SERVICE BULLETIN NO: 28-009

FUEL - DISTRIBUTION FUEL BOOSTER PUMP - DAMAGE TO WIRES DURING INSTALLATION

≡PILATUS≡
PC-7
SERVICE BULLETIN

Lead Protection - Installation
Figure 1

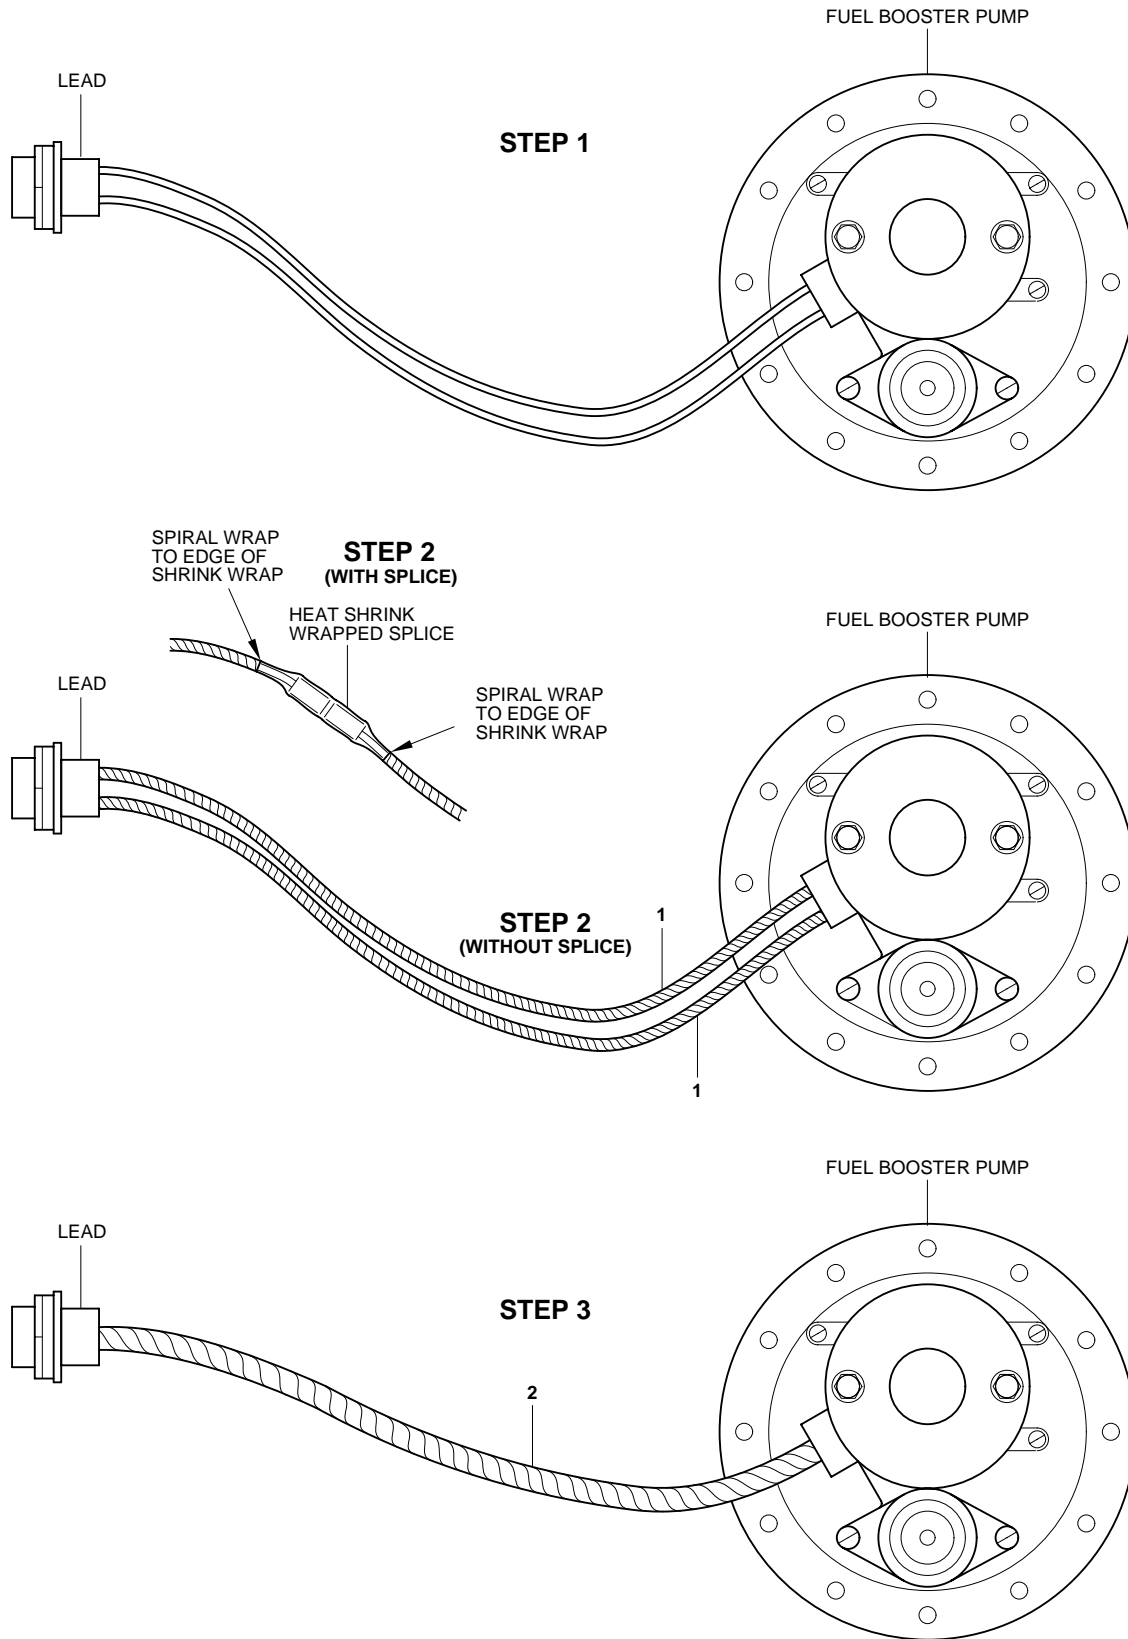
It is possible the electrical power wires (leads) to the left and right fuel pumps are damaged. This damage could cause an electric arc from the leads in an air/fuel mixture which can make a dangerous condition.

The damage can occur to the leads during the installation of the pump. It is also possible that the leads could rub during the operation of the aircraft.

This Service Bulletin gives the instructions to examine the leads and to apply the spiral wrap.

C. Installation of the Lead Protection (Ref. Fig. 1)

- (1) Unwind the fuel-pump lead (the black wire and the white wire) to isolate the wires. Hold the wires in this position.

- (2) Install the spiral wrap on each wire:
 - (a) For a wire with no splice. Wind spiral wrap (1) around the full length of the wire. Twist the spiral wrap (1) to make sure there are no gaps and cut the spiral wrap (1).
 - (b) For a wire with a splice. Wind spiral wrap (1) around the wire between the edge of the shrink wrap and the end of the wire. Twist the spiral wrap (1) to make sure there are no gaps and cut the spiral wrap (1). Do this for each side of the splice.
- (3) Release the black wire and the white wire.
- (4) Wind the spiral wrap (2) around the full length of the black wire and the white wire. Twist the spiral wrap (2) to make sure there are no gaps and cut the spiral wrap (2).

- (3) Install the spiral wrap on each wire:
- (a) For a wire with no splice. Wind spiral wrap (1) around the full length of the wire. Twist the spiral wrap (1) to make sure there are no gaps and cut the spiral wrap (1).
- (b) For a wire with a splice. Wind spiral wrap (1) around the wire between the edge of the shrink wrap and the end of the wire. Twist the spiral wrap (1) to make sure there are no gaps and cut the spiral wrap (1). Do this for each side of the splice.
- (4) Release the black wire and the white wire.
- (5) Wind the spiral wrap (2) around the full length of the black wire and the white wire. Twist the spiral wrap (2) to make sure there are no gaps and cut the spiral wrap (2).
